DCP/NRC1194
NSD-NRC-97-5499
Docket No.: 52-003

SUBJECT: AP600 RESPONSE TO FSER OPEN ITEMS

Enclosure to Westinghouse
Letter DCP/NRC1194

Figure 3.8.3-18

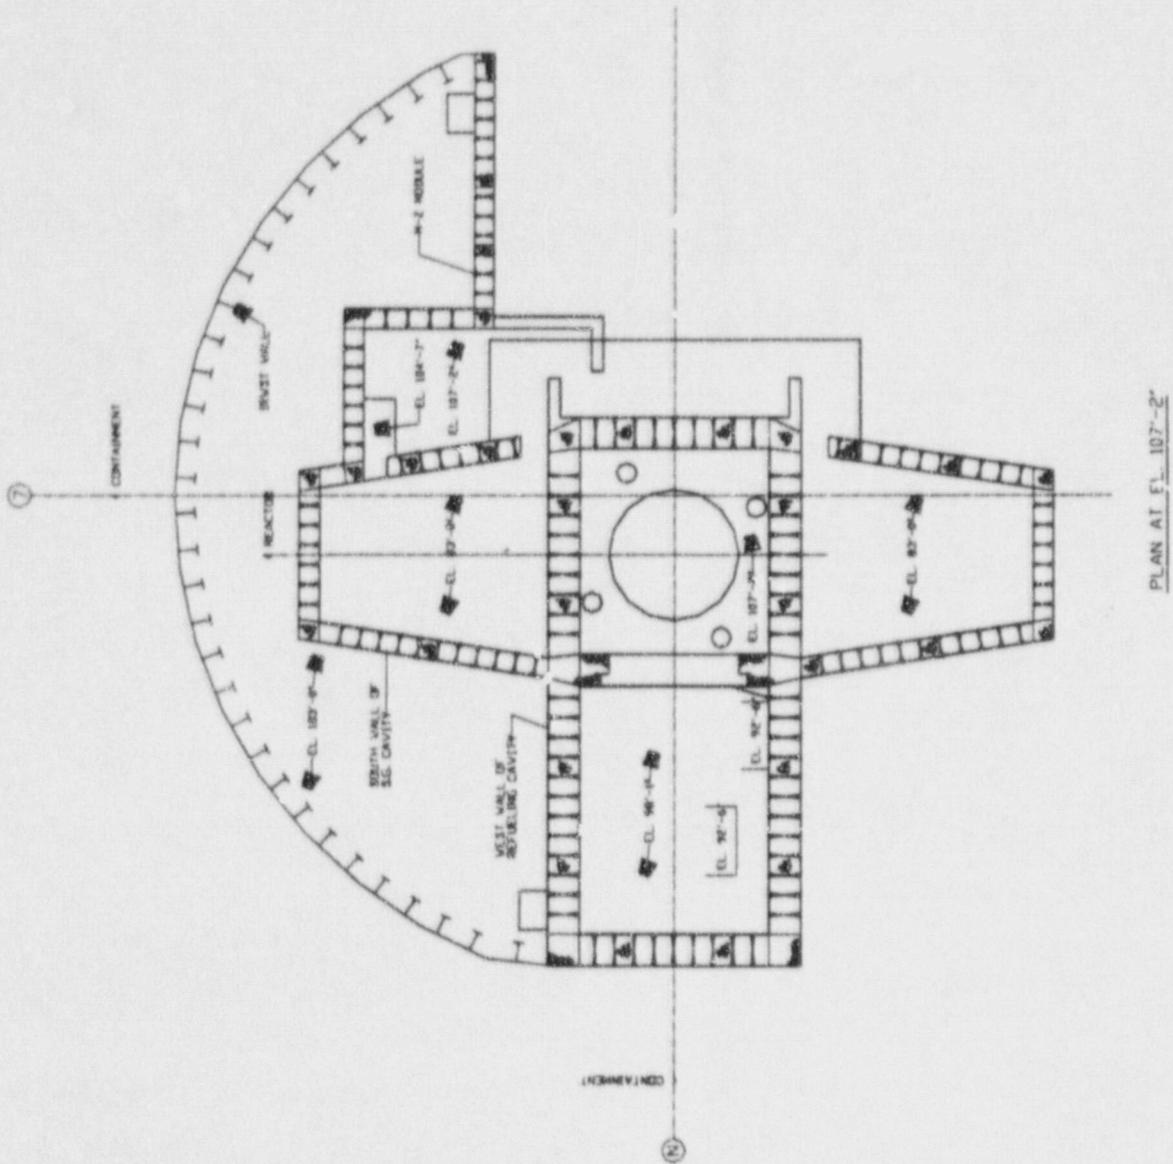
As stated in the SRP, the staff should review a design report in order to obtain design and construction information that is more specific than that contained in the SSAR. The design report can also assist the staff in planning and conducting a structural review. Nonetheless, Westinghouse was unable to provide a design report for the containment internal structures during previous review meetings. Thus, in the submittal dated June 30, 1994, Westinghouse committed to compile design summary reports using the format and attributes described in Appendix C to Section 3.8.4 of the SRP. In addition, these design summary reports would incorporate the criteria acceptable to the staff and would be made available for staff review. This commitment was identified as Open Item 3.8.3.4-12.

In completing its response to this concern, Westinghouse presented two design reports for the staff's review during the meeting on April 14 through 18, 1997. However, neither of these reports was finalized. Westinghouse indicated that further information will be added to the design reports, such as the drawing details for the critical structural wall modules, stress/load/required steel area summary tables for the critical wall sections, and the comparison tables for the ADS pressure loading analyses. Open Item 3.8.3.4-12 will not be closed until Westinghouse finalizes these design summary reports.

Westinghouse had proposed that the critical sections details be provided in a summary report to be referenced from the SSAR. In a meeting Open Item from the January 14, 1997 meeting (summarized in the March 18, 1997 Letter, Attachment 3), NRC staff identified that Westinghouse should include critical section details in a formal revision of the SSAR. Westinghouse has now prepared information for inclusion in the SSAR. Similar information is being provided for the auxiliary buildings in the response to open item 220.128F. The draft design summary reports that were reviewed by the staff in previous meetings are internal Westinghouse documents.

Drawing details for the critical structural wall modules and stress/load/required steel area summary tables for the critical wall sections are included in the SSAR. The comparison tables for the ADS pressure loading analyses were reviewed by the staff during the review meeting and are included in the design summary report.

The thicknesses and locations of these walls which are part of the boundary of the in-containment refueling water storage tank are shown in Table 3.8.3-3 and Figure 3.8.3-18.
